WCAP-16523-NP-A

# **Westinghouse Correlations WSSV and WSSV-T for Predicting Critical Heat Flux in Rod Bundles with Side- Supported Mixing Vanes**

SUBJECT: FINAL SAFETY EVALUATION FOR WESTINGHOUSE ELECTRIC COMPANY  
(WESTINGHOUSE) TOPICAL REPORT (TR) WCAP-16523-P,  
"WESTINGHOUSE CORRELATIONS WSSV AND WSSV-T FOR PREDICTING  
CRITICAL HEAT FLUX IN ROD BUNDLES WITH SIDE-SUPPORTED MIXING  
VANES" (TAC NO. MD0561)

**Response to NRC's Request for Additional Information**  
**By the Office Of Nuclear Reactor Regulation**  
**Topical Report WCAP-16523-P, "Westinghouse Correlations WSSV**  
**and WSSV-T for Predicting Critical Heat Flux in Rod Bundles with**  
**Side-Supported Mixing Vanes" (TAC No. MD0561) (Non-Proprietary)**

**Figure 4-3**  
**TORC M/P CHF Ratio with VIPRE WSSV Constants vs. Local Quality**

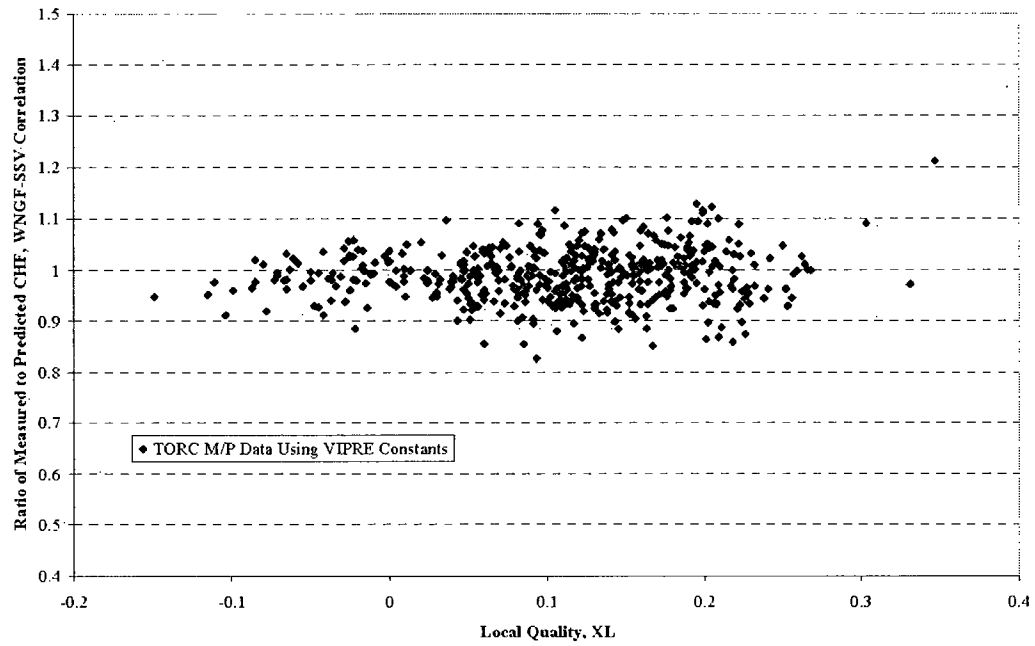
A plot of the supplemental data M/P ratio versus the quality with the form adjustment is shown in Figure 3-3. A plot of the side-supported vane data versus quality with the form adjustment is given in Figure 4-3. These plots demonstrate the adjustment conservatively accounts for [ ]<sup>a, c</sup>.
